## Response to the Reviewers' Comments

The authors would like to thank the reviewers for the precious comments and suggestions on the technical contents and presentation of our manuscript "Runtime Power Management of Battery Electric Vehicles for Extended Range with Consideration of Driving Time," submitted to IEEE Transactions on Very Large Scale Integration (TVLSI.) This revised manuscript has been greatly improved thanks to the reviewers' invaluable advices. We have revised the manuscript faithfully following the reviewers's comments. We include the newly added or significantly modified parts in the revised version of the paper also in Response to Reviewers. We highlight the important technical content changes and set those parts in a red color in the revised paper.

Fig. 2: (a) Range-speed experimental data for Chevrolet Bolt [36] and (b) comparison with simulation results of the proposed EV power model.

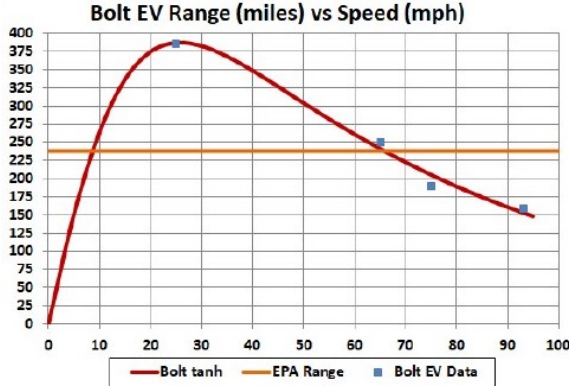
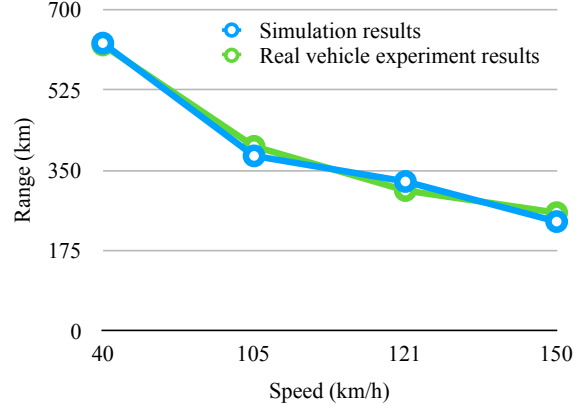
**R1-C2** It is not clear how to validate the power model of EV. As the author mentions that accuracy of power model is quite important, it is good to see the power model in this paper can be validated by some real measurement results.

**R1-A2** Previous eco-driving research is optimized for ICEVs that mandate a (variable-speed) transmission, and thus the resultant eco-driving is not applicable to EVs as we demonstrated in this paper. We previously introduced an

Here goes how we extracted correct coefficients of the EV power equation. We use a vehicle simulator that supports EV as well, ADVISOR, to extract the coefficients of new vehicles starting from known vehicle specifications such as the aerodynamic resistance, rolling resistance, curb weight, and so on. Such data is often published in the users' manual, website and so forth. We further use the vehicle performance data such as the top speed, maximum acceleration, and so on, which are also available on the manuals and website. We iteratively run ADVISOR and derive the model coefficients so that all the known values match among each other. We evaluate the model accuracy with the range-speed real vehicle experiments as shown in Fig. 1(a), which has been published by [32], [33], [34], [35], [36]. We further refine the coefficients until all the available data values match well. Finally, the derived EV power model well matches with the range-speed experimental data as shown in Fig. 1(b) as well as the top speed and maximum acceleration, setting the aerodynamic resistance, rolling resistance, curb weight, etc. with the known (fact) values. The errors of the range-speed simulation is merely 1.4%, the time to approach 60 mph at departure is 7.8%, and the top speed is 3.0%, respectively. We revised the manuscript adding the following paragraph with a new figure in Section III.A on page 3 and 4.

We use ADVISOR to extract the model coefficients of new vehicles starting from known vehicle specifications such as the aerodynamic resistance, rolling resistance, curb weight, and so on. Such data is often published in the users' manual, website and so forth. We further use the vehicle performance data such as the top speed, maximum acceleration, and so on, which are also available on the manuals, commercials and websites. We iteratively run ADVISOR and derive the model coefficients so that all the known data values match among each other. The model coefficient extraction result shows as in Fig. 1. The normalized root-mean-square (RMS) deviation is 5.1%. Table I summarizes the model coefficients of (5) for Chevrolet Bolt.

We further evaluate the model accuracy with the range-speed real vehicle experiments as shown in Fig. 2(a) to confirm the derived power models are close enough to the real vehicle measurement data [32], [33], [34], [35], [36]. We refine the coefficients until all the available data values match well.

As a result, the derived EV power model well matches with the range-speed experimental data as shown in Fig. 2(b) as well as the top speed and maximum acceleration setting the aerodynamic resistance, rolling resistance, curb weight, etc. with the known values. The errors in the range-speed simulation is merely 1.4%, the time for 0-to-100 km/h error is 7.8%, and the top speed error is 3.0%, respectively.

Fig. 12: Velocity profile comparison with  $EDP$ ,  $E^2DP$  and  $E^3DP$  on Serrano Avenue in Anaheim Hills.

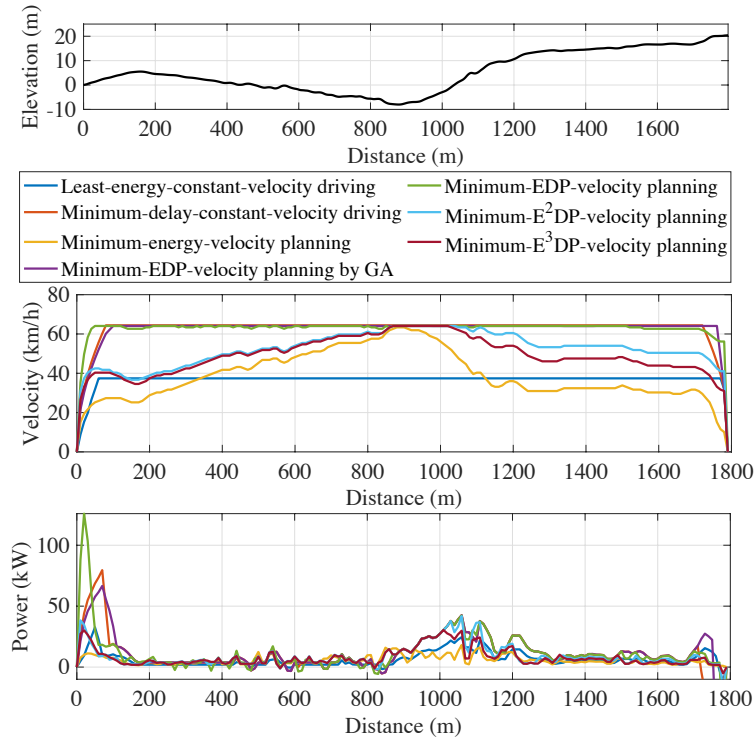
**R1-C3** The optimality of the proposed scheduling algorithm is unclear. The author should add several paragraphs to discuss this topic. It is also to see the comparison baseline is well accepted to show the advantage of the proposed algorithm.

**R1-A3** As we already mention in the previous version of the manuscript, the proposed EDP-aware-velocity planning is not optimal. This is because the EDP-aware-velocity planning is not formulated as DP (we also mentioned this in the previous version of the manuscript), but we used DP referring it as "heuristics." We demonstrated that such heuristics method still very well reduces  $EDP$ ,  $ED^2P$  and  $ED^3P$ . However, as the reviewer pointed out, there was no tangible clue how the resultant solutions are close to the true optimal.

In this revised manuscript, we did spend an extended period of time and added a new content how close the proposed heuristics method is to the true optimal, comparing with the results of Genetic algorithm (GA). GA can hardly be used for a practical solution method as its time complexity is not suitable for real applications. We use the GA results as a golden reference to evaluate the optimality of the proposed heuristics.

Fig. 12 summarizes  $EDP$  of the least-energy-constant-velocity driving, the minimum-delay-constant-velocity driving, the minimum-energy-velocity planning, the velocity planning with  $EDP$ ,  $E^2DP$  and  $E^3DP$  as a metric on the road benchmarks and the minimum- $EDP$ -velocity planning with GA. The proposed velocity planning results in up to 46.2% improvements of  $EDP$  compared with the least-energy-constant-velocity driving. The driving velocity on a flat road is faster than that of the least-energy-constant-velocity driving at the expense of relatively little energy to save driving time. Then, the velocity decreases when climbing the following uphill to spend less motor torque, which saves more energy.

In addition,  $EDP$  of the proposed EDP-aware-velocity planning is merely 4.3% higher than that of the true EDP-minimum-velocity planning on average. Through this results, we confirm that the results of the proposed heuristics are close enough to the true optimal solutions.

We also updated Fig. 12 and Fig. 13:

Fig. 11: Histograms of velocity and acceleration for the proposed energy-aware-velocity planning methods without an acceleration constraint (a) and (b) and with an acceleration constraint (c) and (d), respectively.

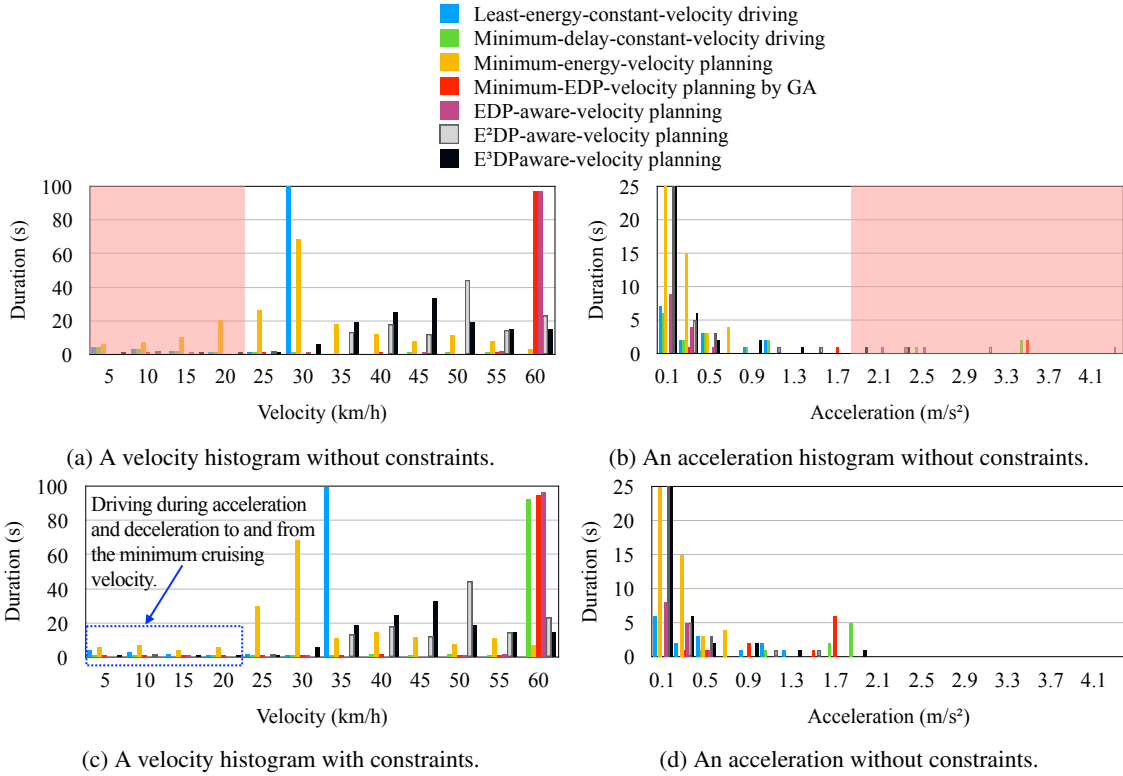
**R2-C2** It would be good to have more discussion on the assumptions of the approach and the experiments, e.g., how much can the velocity be changed in practical scenarios without impeding traffic and causing unsafe situations (also depending on the road conditions and whether it is urban or rural environment I suppose). Currently, there only seems to be one constraint on not slower than 10 km/h.

Fig. 11(a) and (b) show two histograms of the driving schemes in Fig. 12, which do not have velocity and acceleration constraints. We avoid a cruising velocity lower than 25 km/h and an acceleration higher than  $2.0 \text{ m/s}^2$  in this paper without loss of generality. The acceleration of  $2.0 \text{ m/s}^2$  is the same as the maximum acceleration of compact cars designed to be used primarily used in urban areas (13 seconds of 0-to-100 km/h time).

Fig. 11(c) and (d) shows the velocity and acceleration histograms with the constraints. Once we run the DP for the first time without constraints, we analyze the histogram, adaptively determine the minimum cruising velocity and maximum acceleration constraints, and run DP again. We keep the same constraints for online recomputation whenever unexpected interrupts occurs.

We also enforce the minimum acceleration not lower than  $1.0 \text{ m/s}^2$  when the EV starts from a stop sign or a traffic light until the velocity reaches to the minimum cruising velocity not to bother traffic flow. The acceleration of a  $1.0 \text{ m/s}^2$  exhibits 6 second delay to reach 25 km/h. The maximum speed is bounded by the speed limit of each road benchmark.

We quantize the velocity and acceleration values and make a histogram to analyze population of velocity and acceleration for the proposed energy-aware-velocity planning methods. Fig. 11(a) and (b) show two histograms of the driving schemes in Fig. 12, which do not have velocity and acceleration constraints. We avoid a cruising velocity lower than 25 km/h and an acceleration higher than  $2.0 \text{ m/s}^2$  in this paper without loss of generality. The acceleration of  $2.0 \text{ m/s}^2$  is the same as the maximum acceleration of compact cars designed to be used primarily used in urban areas (13 seconds of 0-to-100 km/h time).

Fig. 11(c) and (d) shows the velocity and acceleration histograms with the constraints. Once we run the DP for the first time without constraints, we analyze the histogram, adaptively determine the minimum cruising velocity and maximum acceleration constraints, and run DP again. We keep the same constraints for online recomputation whenever unexpected interrupts occurs.

We also enforce the minimum acceleration not lower than  $1.0 \text{ m/s}^2$  when the EV starts from a stop sign or a traffic light until the velocity reaches to the minimum cruising velocity not to bother traffic flow. The acceleration of a  $1.0 \text{ m/s}^2$  exhibits 6 second delay to reach 25 km/h. The maximum speed is bounded by the speed limit of each road benchmark.

Fig. 8: Altitude changes in the real road benchmarks.

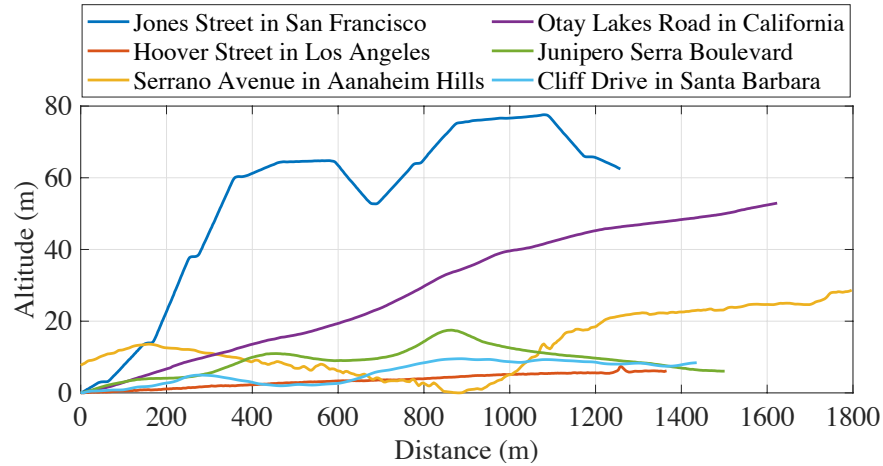
**R2-C3** Related to the last point, it would be good to have more discussion on the road benchmarks, e.g., how they are generated and how representative they are. The optimization results significantly depend on road slope. It would be good to use a variety of real road segments for testing.

**R2-A3** We appreciate the reviewer's comment. We replaced the previous synthetic road benchmarks with the real road benchmarks. We made six new real road benchmarks from various locations in California. The first three roads are in cities. Jones Street in San Francisco and Hoover Street in Los Angeles are two representative city landscapes such as hills and flat roads, respectively, and Cliff Drive in Santa Barbara is a mixture of those. The second two roads are in mountain areas: Serrano Avenue in Anaheim Hills and Otay Lakes Road in San Ysidro

Mountain in California. The last road is Junipero Serra Boulevard connecting San Francisco and San Jose. The details of road data is summarized in Table II, and Fig. 8, which visualize the altitudes of the road benchmarks. We also revised all the associated contents with the new real road benchmarks.

We choose six roads from various locations in California and make real road benchmarks. The first three roads are in cities. Jones Street in San Francisco and Hoover Street in Los Angeles are two representative city landscapes such as hills and flat roads, respectively, and Cliff Drive in Santa Barbara is a mixture of those. The second two roads are in mountain areas: Serrano Avenue in Anaheim Hills and Otay Lakes Road in San Ysidro Mountain in California. The last road is Junipero Serra Boulevard connecting San Francisco and San Jose. The details of road data is summarized in Table II, and Fig. 8, which visualize the altitudes of the road benchmarks.
